**IMPORTANT ORIGINAL EQUIPMENT MANUFACTURER
RECALL**

CSR 510

Cummins C2302 - Fuel Heater Module

***** IMPORTANT SAFETY RECALL *****
NHTSA Recall No. 20E-018
Cummins Campaign #C2302

Navistar® CE Bus and 1300 FBC Fuse Removal Instructions (Reference Figure 1 below)

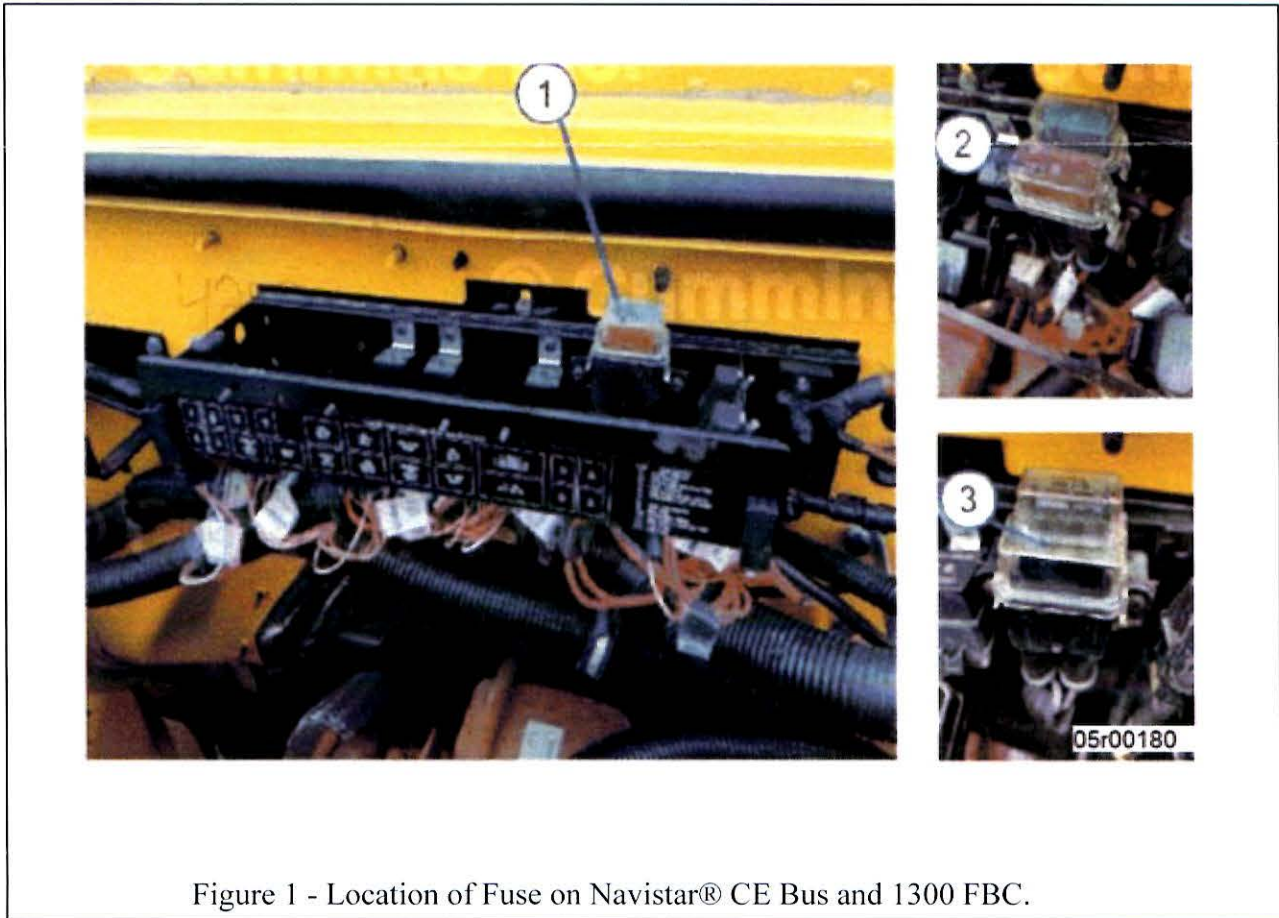
In the meantime, to mitigate the safety risk, Cummins advises you to remove the fuel heater fuse as shown in Figures 1, 2 or 3 below (based on the vehicle).

1. Disconnect vehicle battery.
2. Locate red 50 Amp or green 30 Amp Maxi Fuse on under hood fuse panel.
3. Remove fuse cap and discard red or green Maxi Fuse.
4. Reinstall fuse cap. Do **not** replace fuse.
5. Reconnect vehicle battery.

Figure 2 - Location of 30A or 40A Fuse on Navistar® MV/HV/TC.

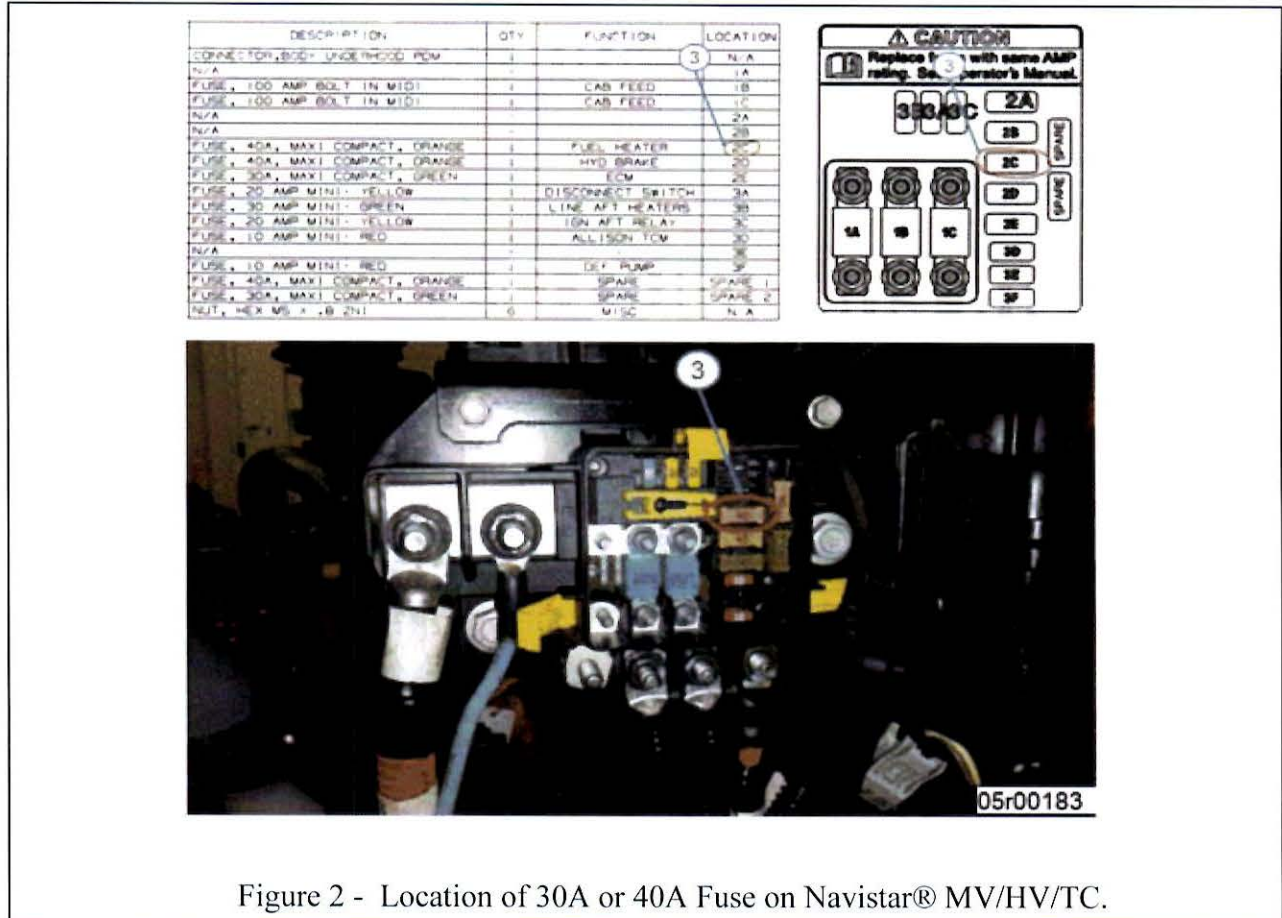
Navistar® MV, HV and TC Commercial Bus (some DuraStar (4300)/WorkStar (7300)) Fuse Removal Instructions (Reference Figure 2 below)

1. Disconnect vehicle battery.
2. Remove 30 or 40 amp fuse located at 2C cavity.
3. Reconnect vehicle battery.

Figure 3 - , Location of Fuse on Navistar® DuraStar (4300) / WorkStar (7300) / HC Commercial Bus

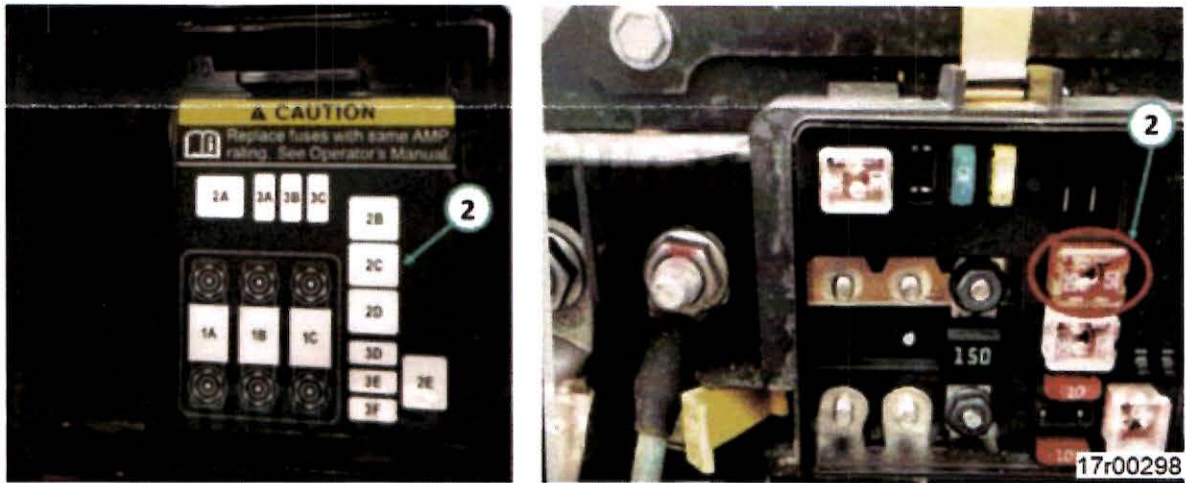
Navistar® DuraStar (4300) / WorkStar (7300) / HC Commercial Bus Fuse Removal Instructions (Reference Figure 3 below)

1. Disconnect vehicle battery.
2. Remove Power Distribution Module (PDM) cover, located under the hood on the driver side of the vehicle.
3. Remove fuse located at cavity 2C.
4. Reconnect vehicle battery.
